UNITED STATES PATENT AND TRADEMARK OFFICE

Office Action Summary	Application No. 10/780,192	Applicant(s) BROCHU ET AL.	
	Examiner Chi Q. Nguyen	Art Unit 3635

DETAILED ACTION

FIG. 1.

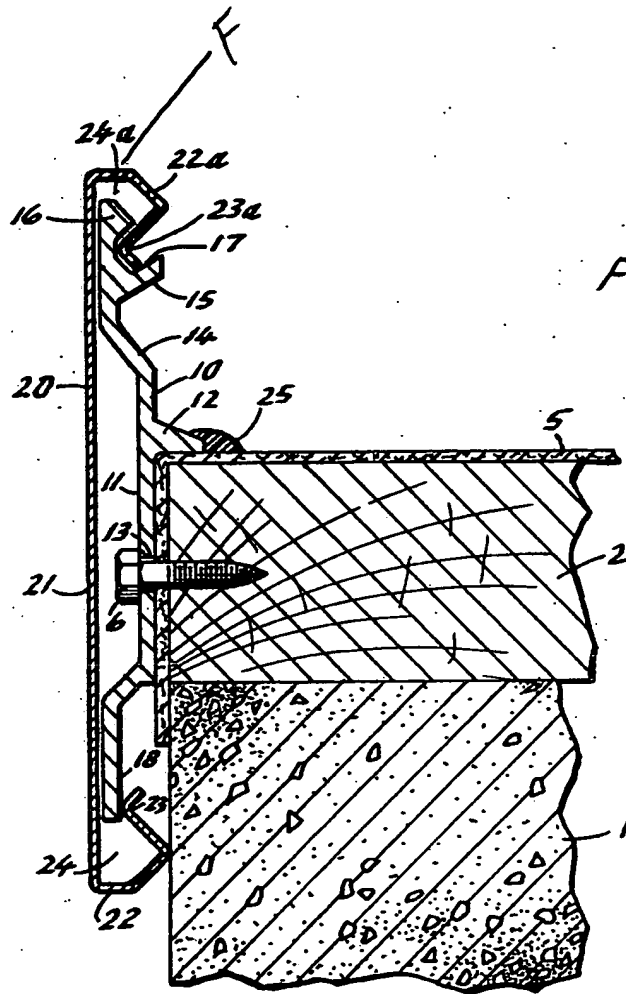
In regard claim 1, Butzen teaches a fascia system comprising a first member 20 and a second member 10, said first member 20 having an upper section, a drip edge

22a formed at an extremity of said upper section, a second lower section (where 21 points to) which includes a generally vertical extending portion 21 having first cooperative locking means 24 associated therewith, said second member 10 comprising a fascia member 1 having second cooperating locking means 17 at an upper portion (where 16 points to), the first cooperative locking means 24 hold said fascia member 1 in position, said second member 10 having a generally planar central portion 11, and an inwardly extending flange 18 arrangement at a bottom end of said generally planar portion 11 (see Fig. 1).

In regard claim 2, wherein said upper section of the first member 20 having a first portion F (see attachment of Fig. 1) and a second portion 22a angled downwardly with respect to the first portion F.
